UNITED STATES OF AMERICA
NUCLEAR REGULATORY COMMISSION

In the Matter of)
)
CONSOLIDATED EDISON COMPANY) Docket No. 50-247
OF NEW YORK, INC.)
(Indian Point Station,)
Unit No. 2))

AMENDMENT NO. 1 TO
APPLICATION FOR AMENDMENT
TO OPERATING LICENSE

Technical Specification
Page Revisions

Figure 3.1-3

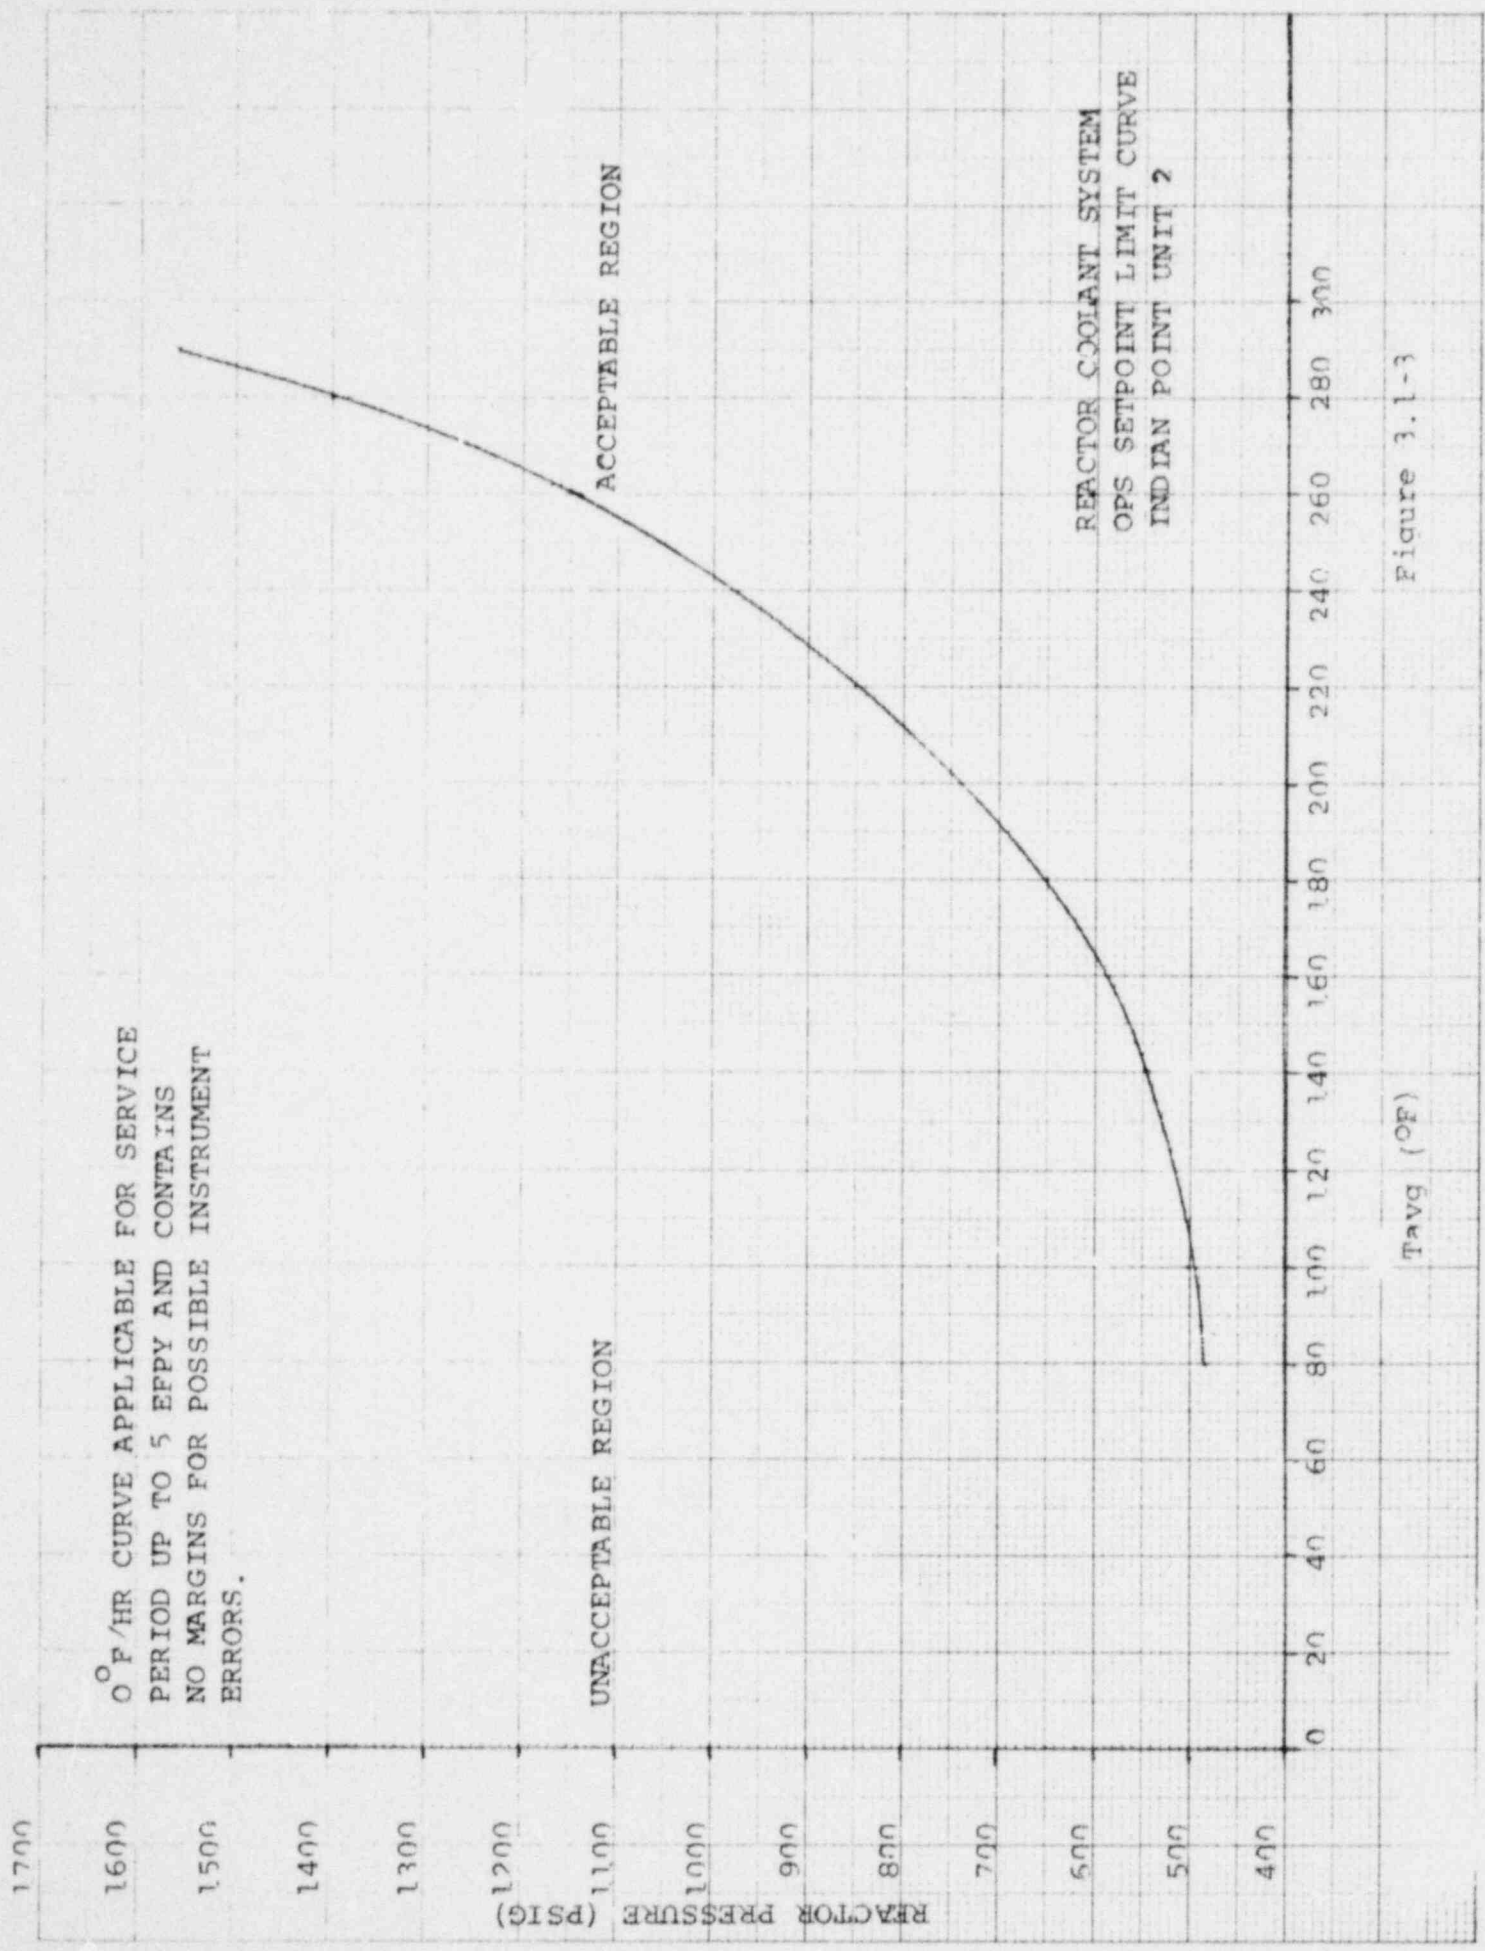
The OPS has been designed to withstand the effects of the postulated worst case for Mass Input flow (i.e., Single S.I. pump) without exceeding the 10 CFR 50, Appendix G, limits. Figure 3.1-3 shows the maximum setpoint curve of the OPS PORVs which is sufficiently below the 10 CFR 50, Appendix G, limits such that PORV overshoots do not result in peak RCS pressures exceeding the 10 CFR 50, Appendix G, limits. Thus it is acceptable to energize one S.I. pump when the OPS is armed.

REACTOR COOLANT SYSTEM
OPS SETPOINT LIMIT CURVE
INDIAN POINT UNIT 2
